KEENE PLANNING BOARD
Council Chambers, Keene City Hall
June 22, 2026
6:30 PM

AMENDED AGENDA

PLANNING BOARD
MEETING MINUTES

STAFF REPORT – CONTINUED PUBLIC HEARING

Figure 3. Snippets showing the previous proposed design for the street-facing building facades and the updated design.

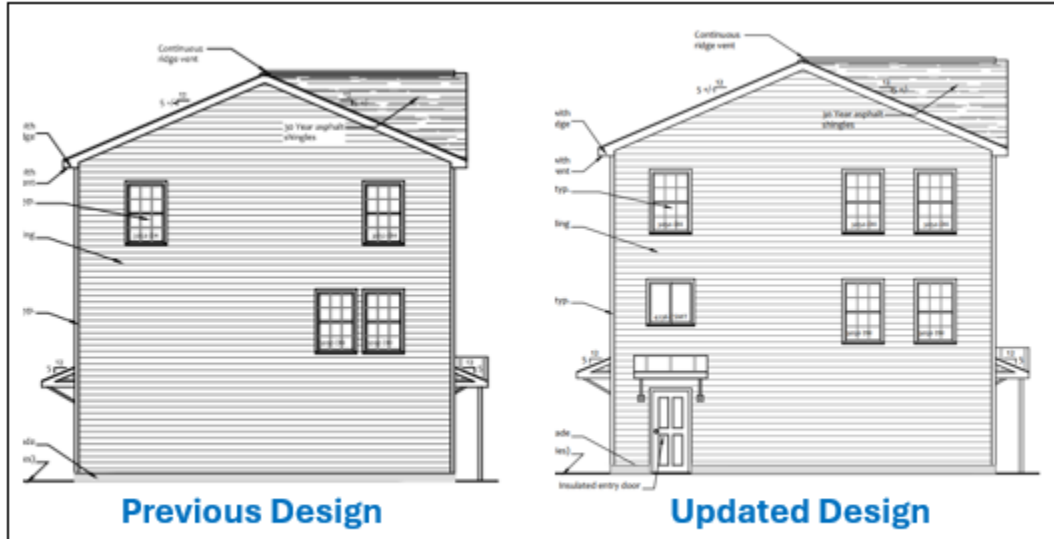
In response to these comments, the applicant has submitted revised architectural elevations that include a door on the gable end facing the street with a small roof above. In addition, two more windows were added along these facades and the window locations were re-aligned to be more regular (Figure 3). The applicant has noted that they intend to bring several concept plans to the June Board meeting to explain why other building orientations, such as a north-south orientation, were not chosen for the site layout.

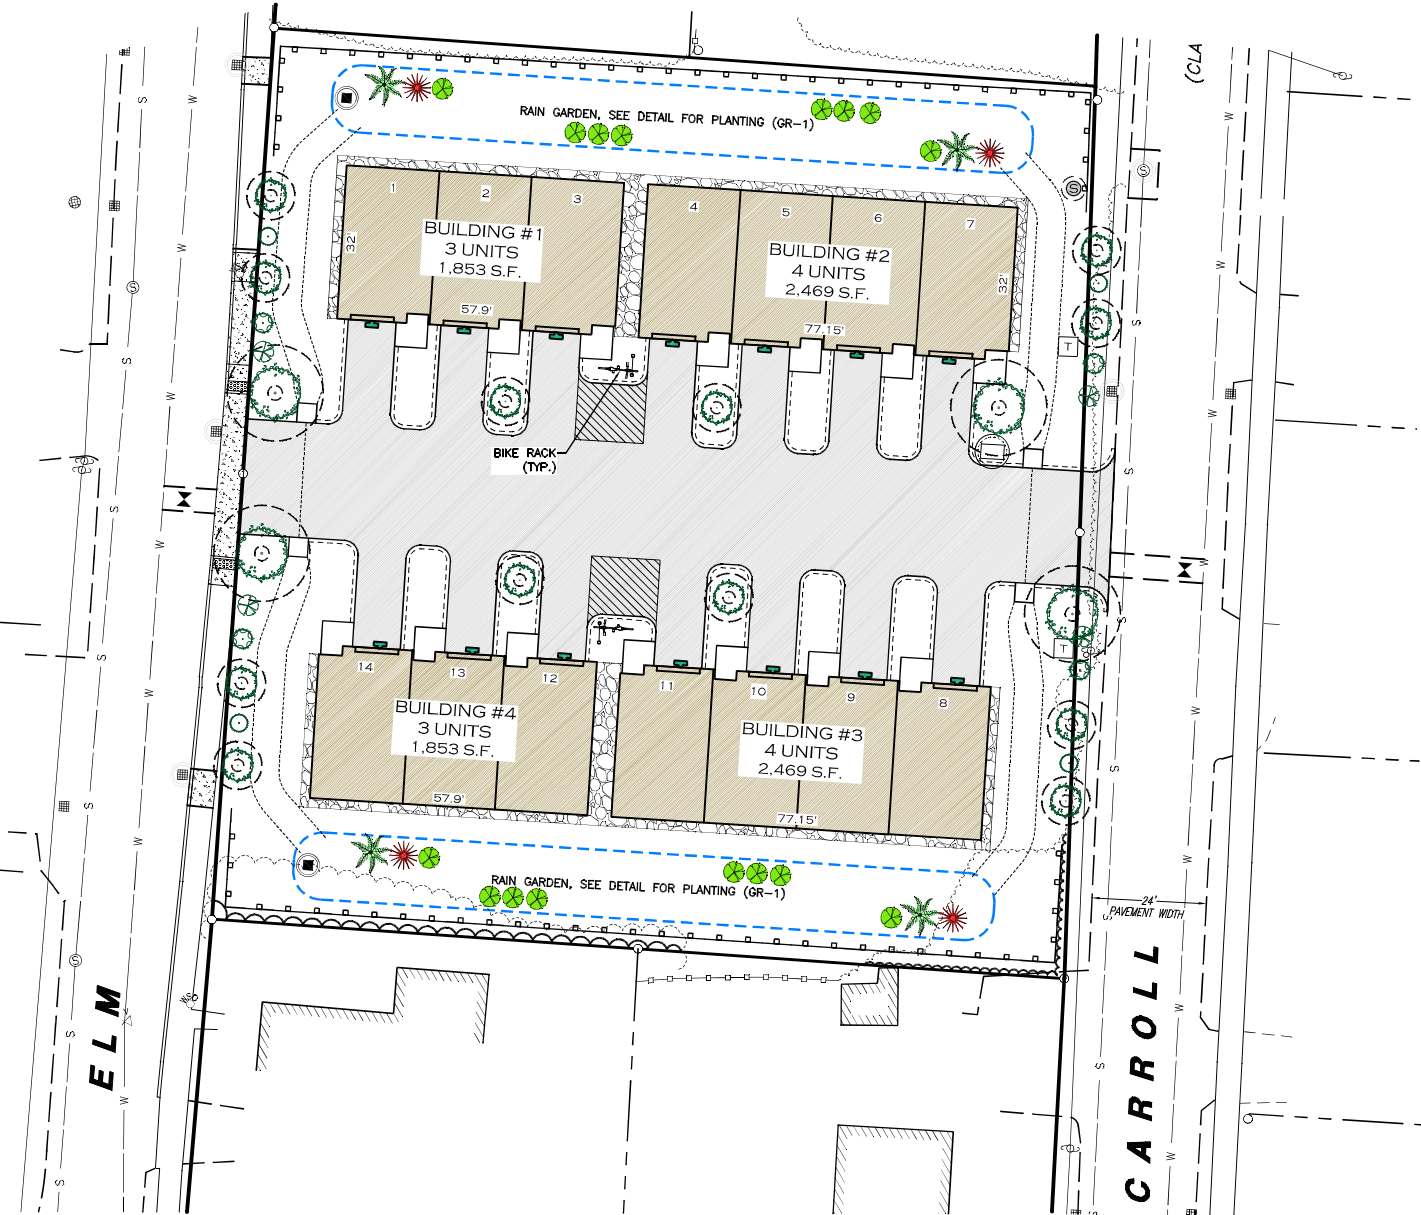
- 561
- 562 1. Submittal of a revised site plan that shows the installation of one, 3-inch caliper American
563 Linden tree and one 3-inch caliper Swamp White Oak in place of the proposed Red Maple
564 trees that are currently shown on the plan.
 - 565 2. Addition of a note on the plan stating that the Best Management Practices described in an
566 NH DOT Publication shall be utilized during construction.
 - 567 3. Submittal of a new design for the rain garden that preserves three mature trees on the north
568 end of the site which were previously proposed to be removed.
 - 569 4. Submittal of a salt reduction plan that includes operation protocols to prevent unwanted
570 chemical going into the rain garden.
 - 571 5. Submittal of a revised site plan showing pervious pavement for the rear parking spaces.

- 692 d. Submittal of a revised site plan that shows the installation of one 3-inch caliper
693 American Linden tree and one 3-inch caliper Swamp White Oak in place of the two
694 proposed red Maple trees.
